SFERNICE / SPECTROL / MCB POSITION SENSORS 248 & 249 General product evolution

DESCRIPTION OF CHANGE:

Product & Packaging change: refer to page 2 for change detail
All other products specifications remain unchanged.

Product change

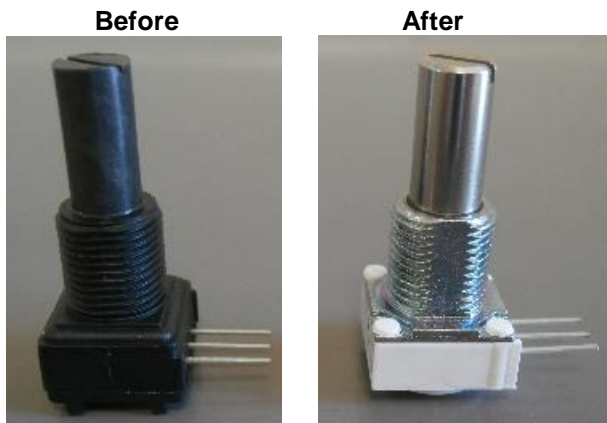
<i>Changes</i>	<i>Before</i>	<i>After</i>
Bushing material	Black plastic bushing	Grey Zamak zinc plated
Shaft material	Black plastic shaft	Copper alloy Ni plated
Housing color	Black	White
Max. tightening torque	50 Ncm for 1/4 " bushing, 70 Ncm for 3/8"	150 Ncm
Lead length	6,9 mm	8,5 mm
Stamping	Part number	Variation law & nominal ohmic value
Hardware	Mounted	Not mounted

Updated product drawing

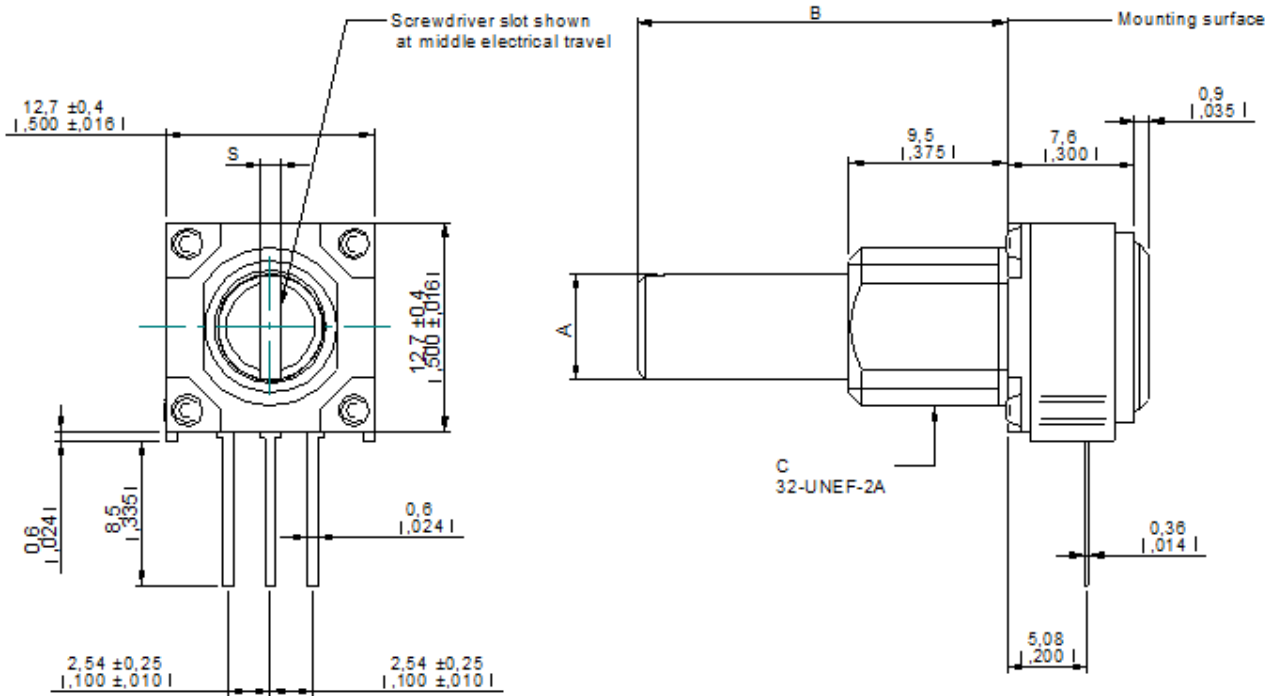
A	B	C	S
Version Bushing / Shaft	Shaft		Bushing	Screwdriver slot
	Ø	L	Ø	Width
B/BH	1/8"	3/4"	1/4"	0,8
F/GJ	1/4"	7/8"	3/8"	1,2
